# PERMIT

SEWAGE DISPOSAL SYSTEM

MARYLAND STATE DEPARTMENT OF HEALTH

ADDRESS: Clarksville Pike Ellicott City, Md. 21043 PHONE 730 -8495

PERMIT CARD

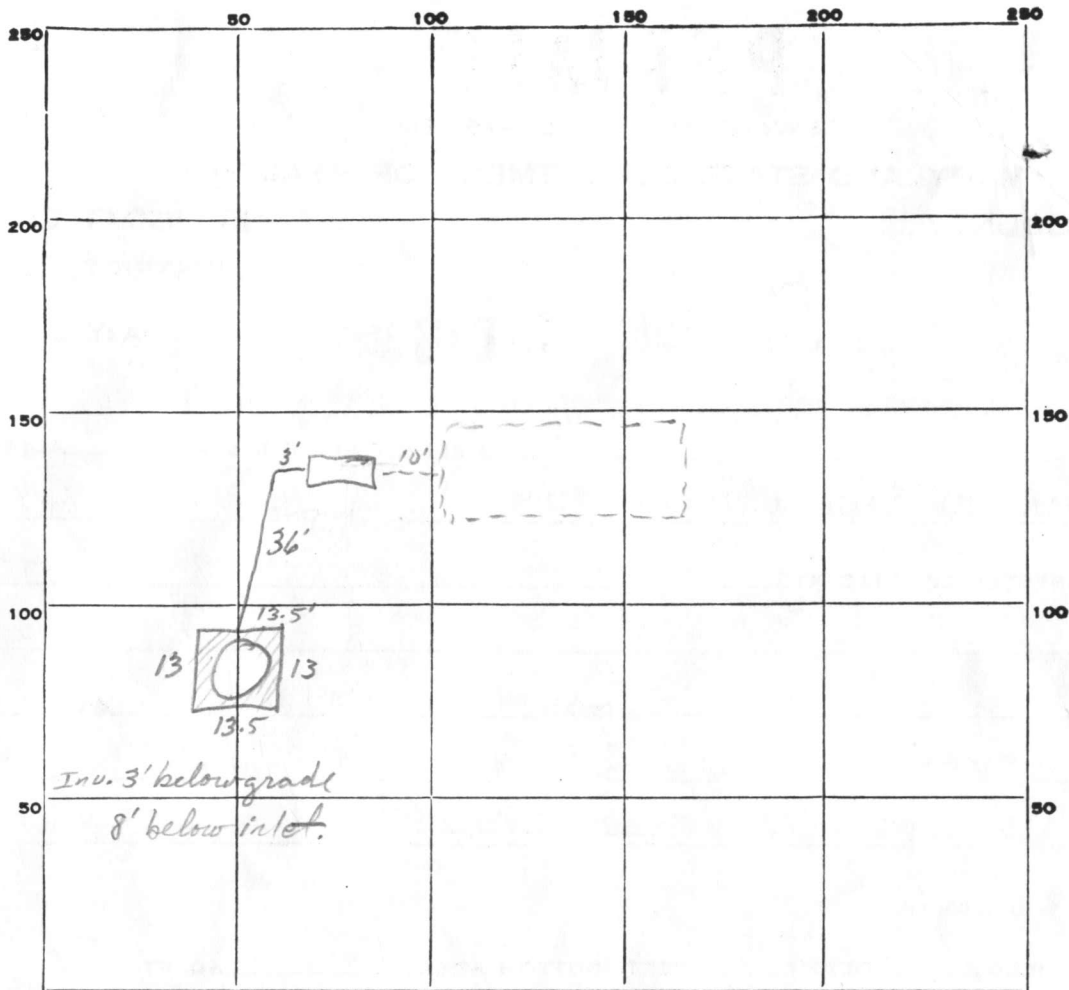
REMARKS *8/15/77: Must see house to sewer connection, T.S.O.*  
*3/1/78: House occupied w/ no apparent problems, T.S.O.*

OTHER DRY WELL - to have 125 square feet per bedroom below inlet. Inlet to be 3 feet below original grade and maximum depth 11 feet. Location per owner's request is 138 feet from Sharman Lane and 14 feet from left property line when facing lot from Sharman Lane. If trench and dry well used call this office.

NOTE: INSTALL STAND PIPE ON SEPTIC TANK AND DRY WELL. STAND PIPES MUST BE 6 INCHES IN DIAMETER. CAST IRON, CONCRETE OR TERRA COTTA ACCEPTED.

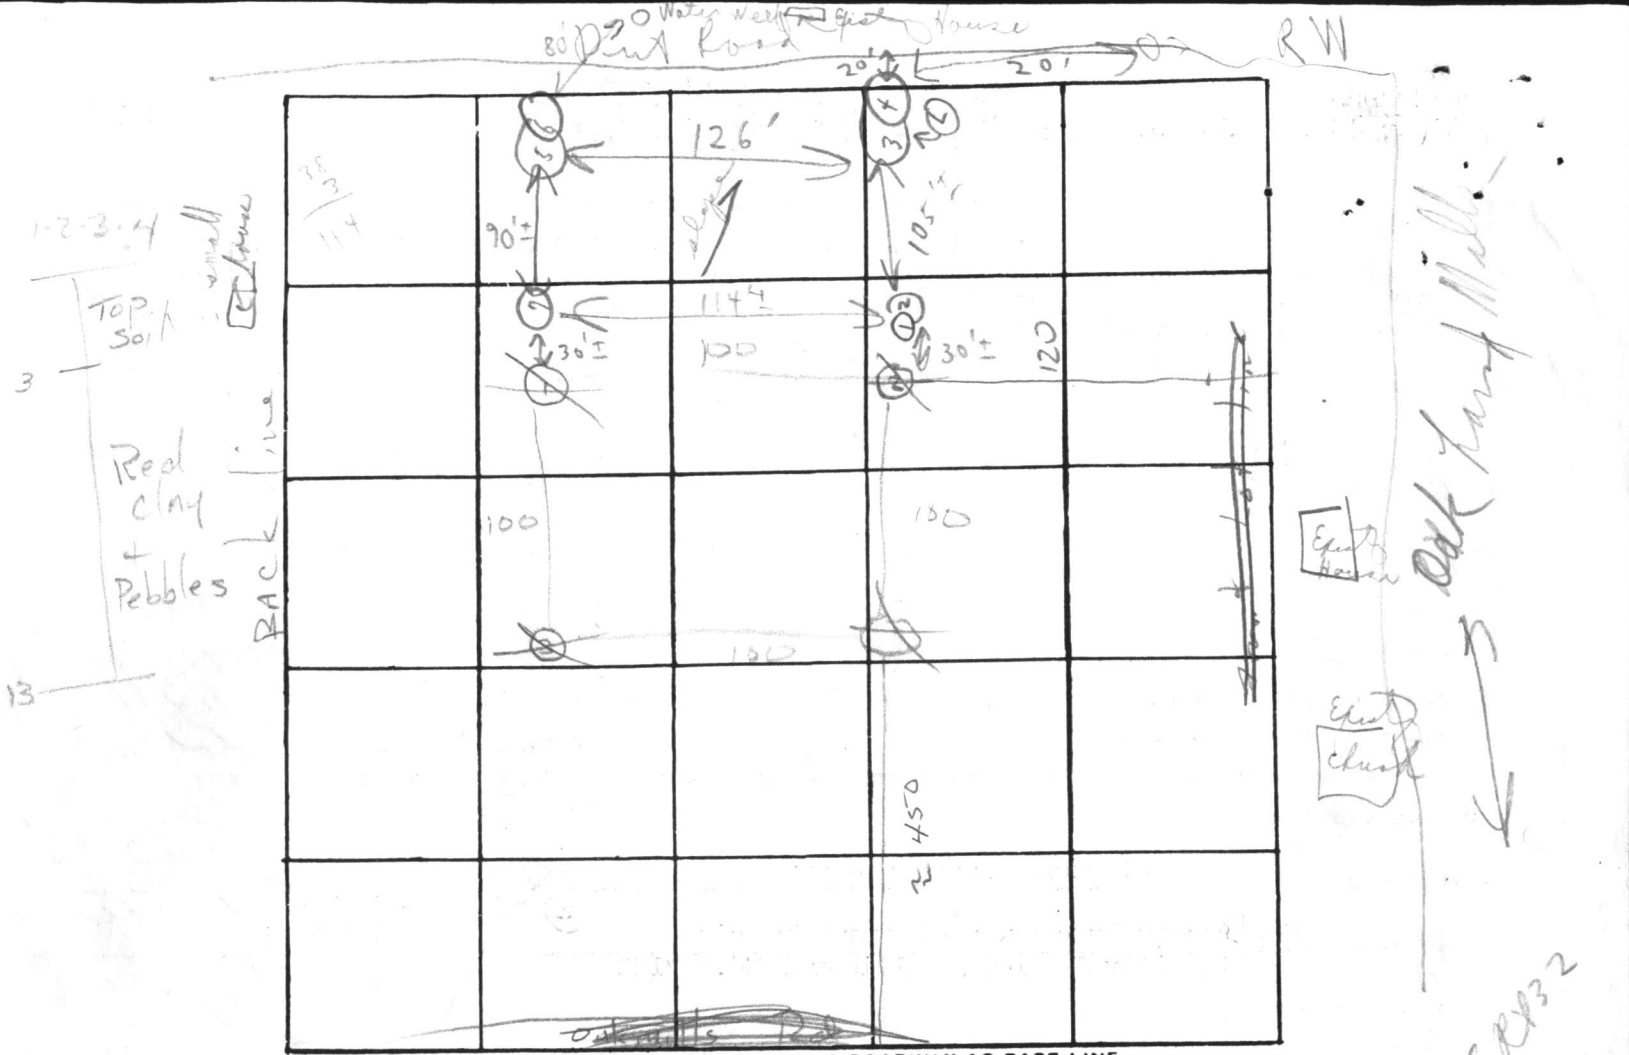
HOLD PENDING FURTHER TESTS DATE future Francis

REASONS FOR REJECTION OR HOLDING for certified holes by supervisor

6/5/77 (Note tests in different area)  
6/16/77 Copy received (Hold for P.W.M. Public water available) CBS  
6/15/77 ok per D.W.M. if use Public Water

Hold for supervisor Mr. Francis future  
 Tested in open field can connect to public water  
 other people on public water  
 ALSO PRESENT: Barth - older man & helper  
 City water?

Per P. W.P. R 132  
 P in hole  
 Dry Well  
 Trench 9' deep  
 shallow  
 Public Water  
 dry to 13'  
 dry

Soil profile  
 + 5' sand  
 texture  
 below  
 clay

Dry well to have 125 sq ft

per bedroom below inlet. Inlet to be 3' below original grade and maximum depth 11' location per owner is 138' from Sharmar Lane and 14' from left property line when facing lot from Sharmar Lane

dry trench and dry well used - must do the following

- ① Trench maximum depth 9' Inlet at 3' below original grade
- ② 5' earth buffers between dry well and trench
- ③ 2 inspections of LOT NO.
